Product Change Notice (PCN)

Subject: Carrier Tape change for Renesas Product ISL91108* WLCSP Packaged Product

Publication Date: 3/27/2019

Appendix A- Comparison of Carrier Tape Dimension

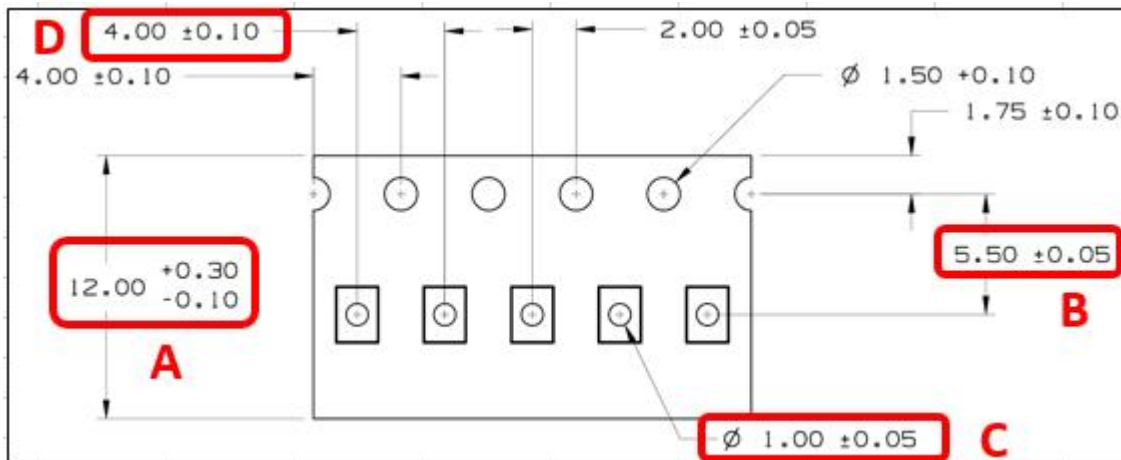
1. Lokreel width comparison table was removed. Because the carrier tape width will maintain as 12mm, therefore there is no change to the lokreel width.
2. The new carrier tape width (Code "A" as shown in Appendix A) will maintain as 12mm (no change)
3. The corresponding pocket dimension were revised as outlined in Appendix B.

This notice is to inform you that Renesas has qualified a change that standardizes the Carrier Tape used for tape and reel packing of the listed Renesas ISL91108* WLCSP (Wafer Level Chip Scale Package) packaged products. The changes are not expected to affect the automated pick and place equipment used for board mount assembly operations. The differences are outlined in Appendix A and B.

#	Code	Dimension	Existing Carrier Tape	New Carrier Tape	Summary
1	A	Carrier Tape Width	12.00 mm + 0.30 mm - 0.10 mm	12.00 mm + 0.30 mm - 0.10 mm	No change
2	B	Index Hole to Pocket Hole Width	5.50 mm ± 0.05 mm	5.50 mm ± 0.05 mm	No change
3	C	Pocket Hole Diameter	1.00 mm ± 0.05 mm	1.00 mm ± 0.05 mm	No change
4	D	Carrier Tape Indexing pitch	4.00 mm ± 0.10 mm	4.00 mm ± 0.10 mm	No change
